Traffic Engineering Letter

To	Platting 88 Pty Ltd	Date	17 April 2026
Prepared by	Kevin Liu, Modus Traffic Engineer	Approved by	Harj Singh, Modus Executive Director (RPEQ 22364)
Location	160 Miles Platting Road, Eight Mile Plains		
Subject	Proposed Subdivision Development - Traffic Engineering Letter		
Status	Final	Attachments	Appendix A: Council Further Advice Appendix B: Revised Development Plans Appendix C: Swept Path Assessment

RE: Further advice

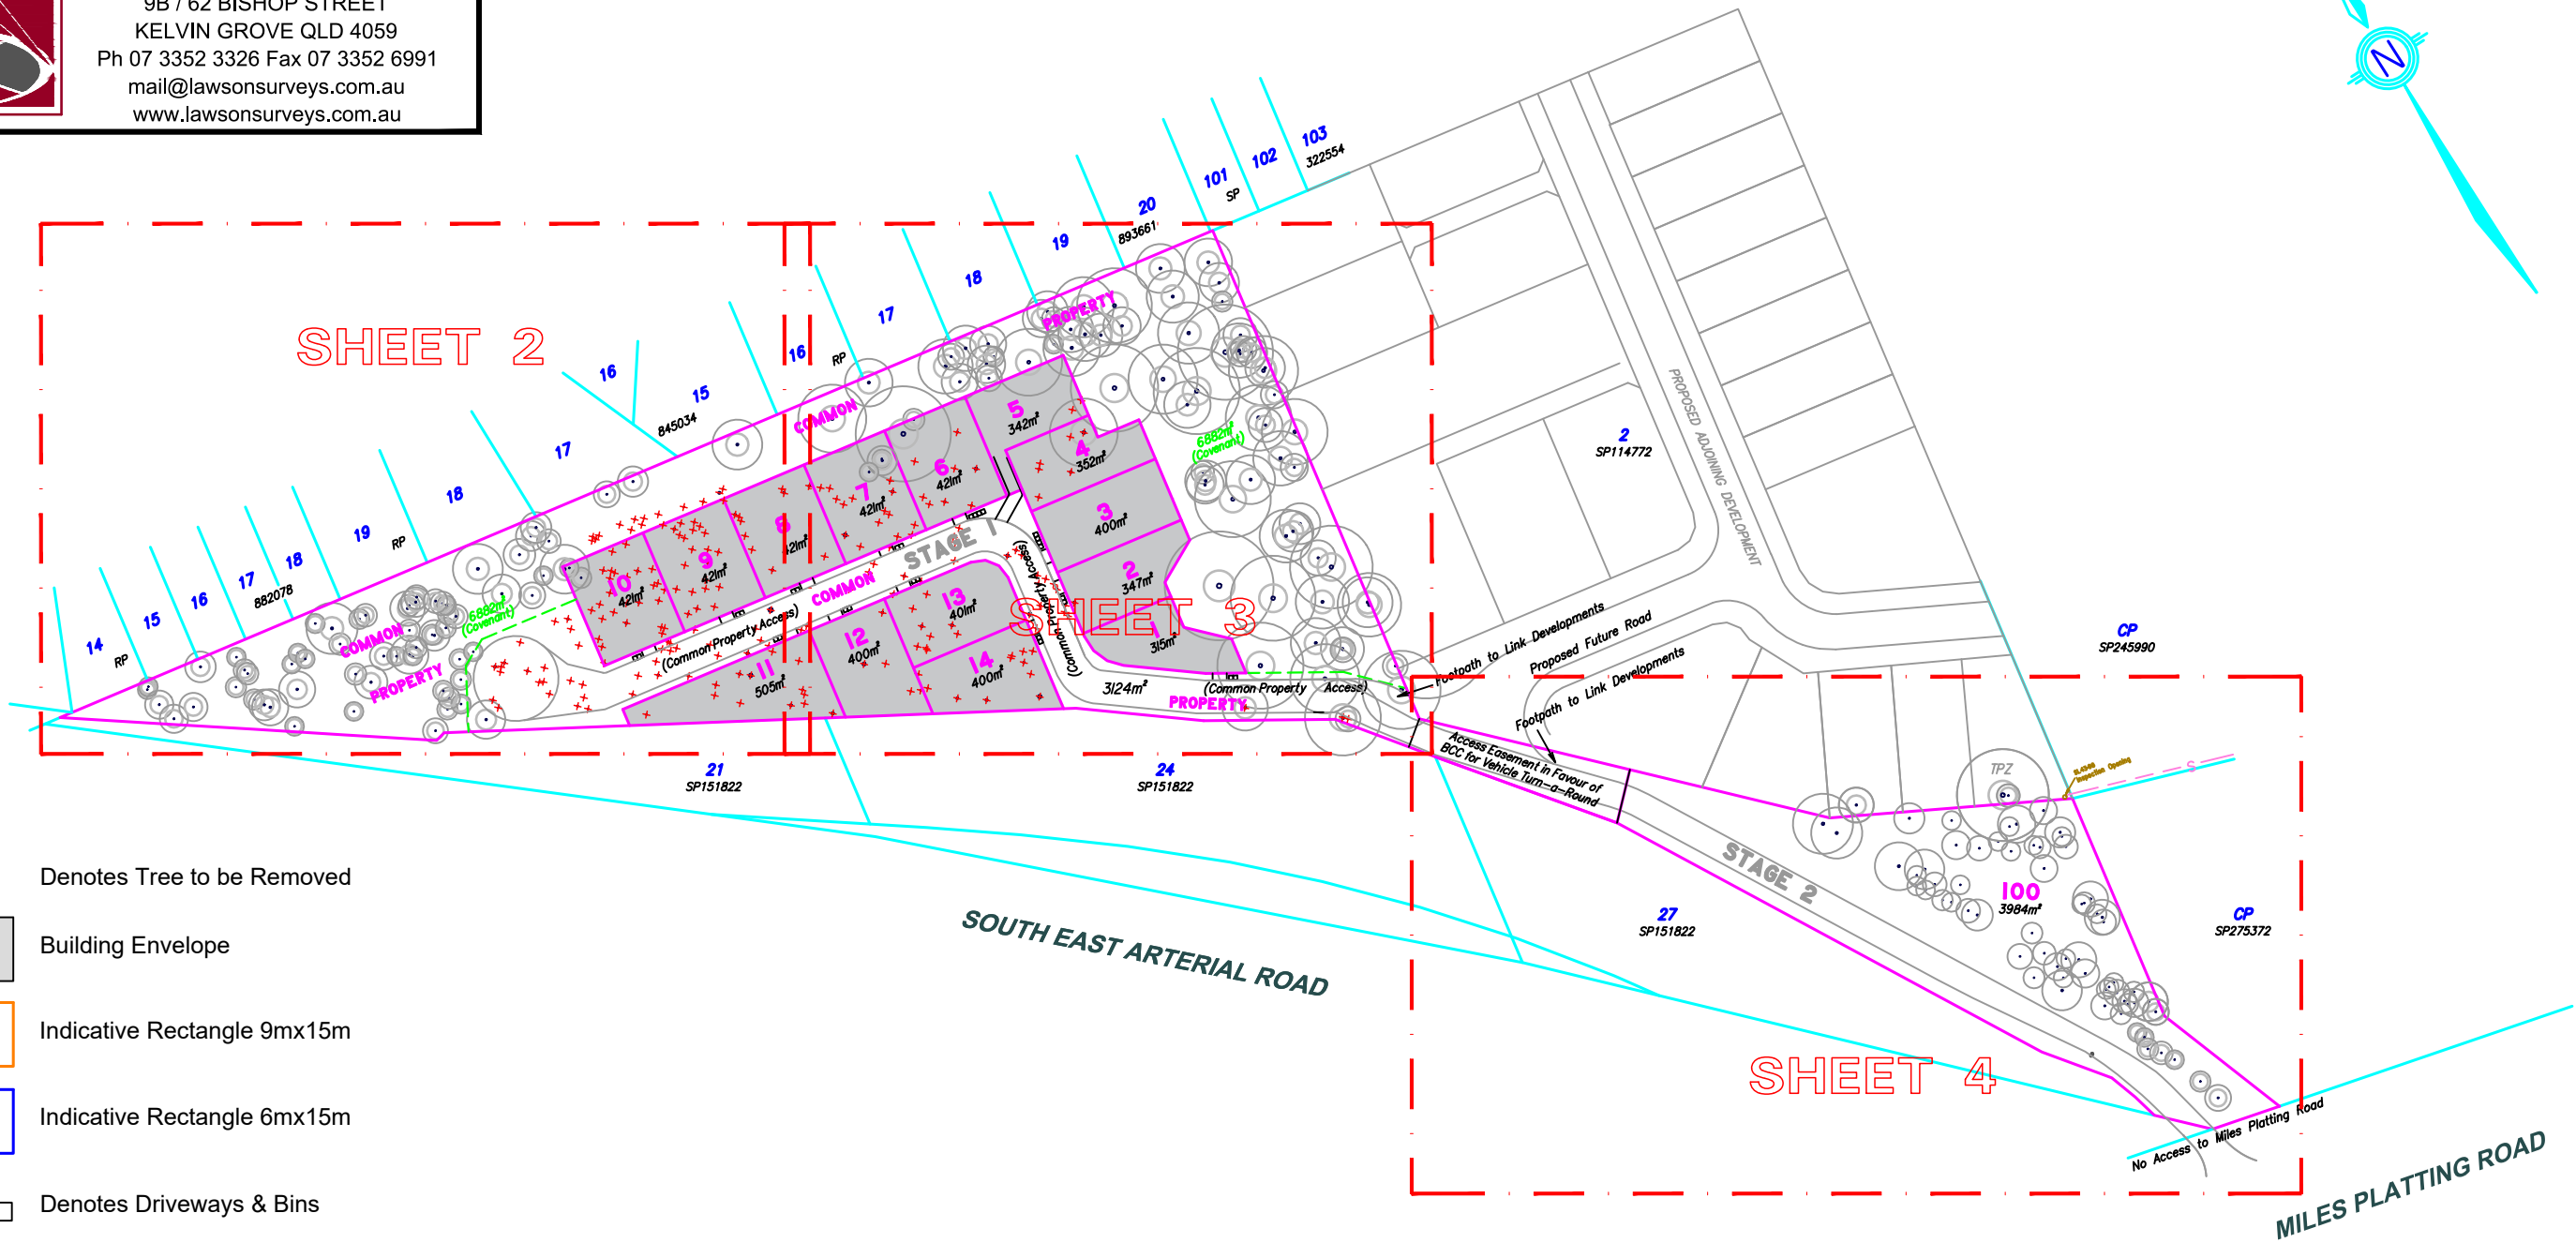
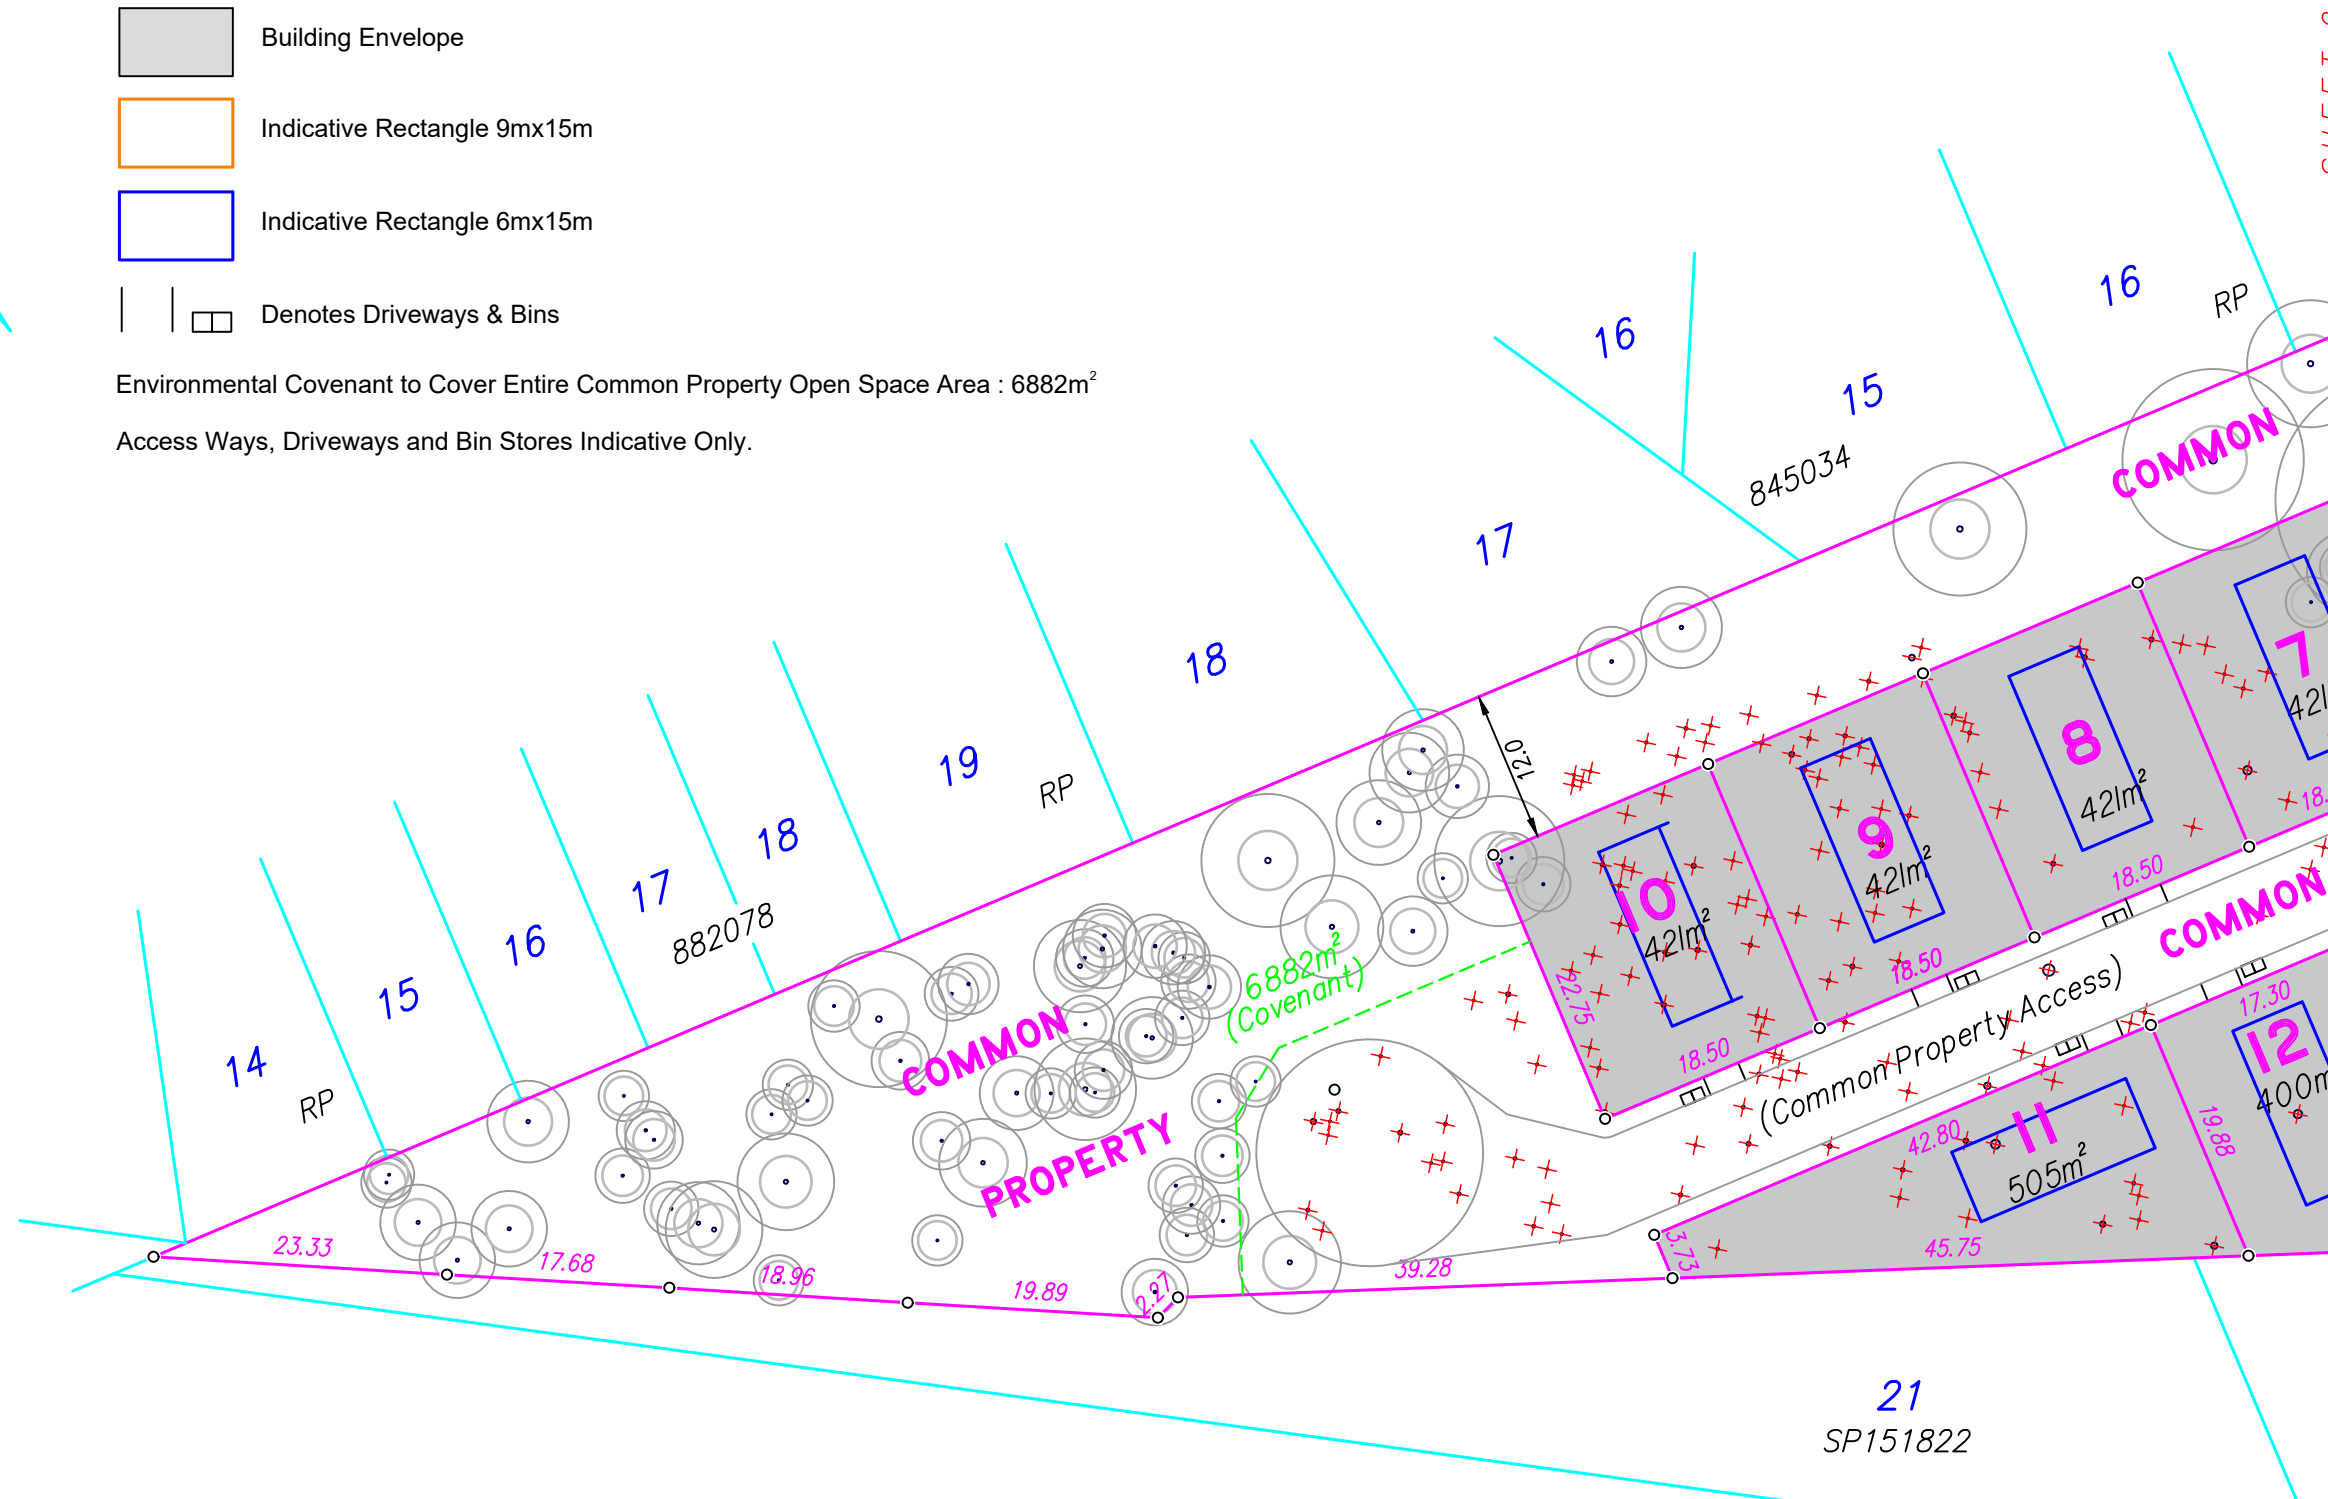
A review of the 'Structure Plan – Stage 1' and suite of 'Subdivision Proposal Plan – Stage 1 & Stage 2, and review of the 'Concept Services Layout Plan Sheet 1 – 3' has noted that the development has provided a minimum carriageway width of 10m. However, the pavement width is 7.5m wide, with a minimum verge width of 1.5m on the northern side and only a 1m wide verge width on the southern side in lieu of a 6.5m wide pavement width and 1.5m wide verge on both sides. Provide the following:

- a) Amended development plans which clearly demonstrates the development has been provided with a minimum 10m wide CTS, including a 6.5m carriageway width and 1.5m wide verges on the northern and southern sides of the carriageway.*

The amended development plans have been prepared to clearly demonstrate compliance with the required minimum 10.0m Community Titles Scheme (CTS) corridor width across the full extent of the proposed road.

The revised cross section now provides the carriageway width of 10m (min) as following:

- ▶ 6.5m (min) carriageway paved width,
- ▶ 1.5m (min) verge width on the northern side,
- ▶ 1.5m (min) verge width on the southern side.
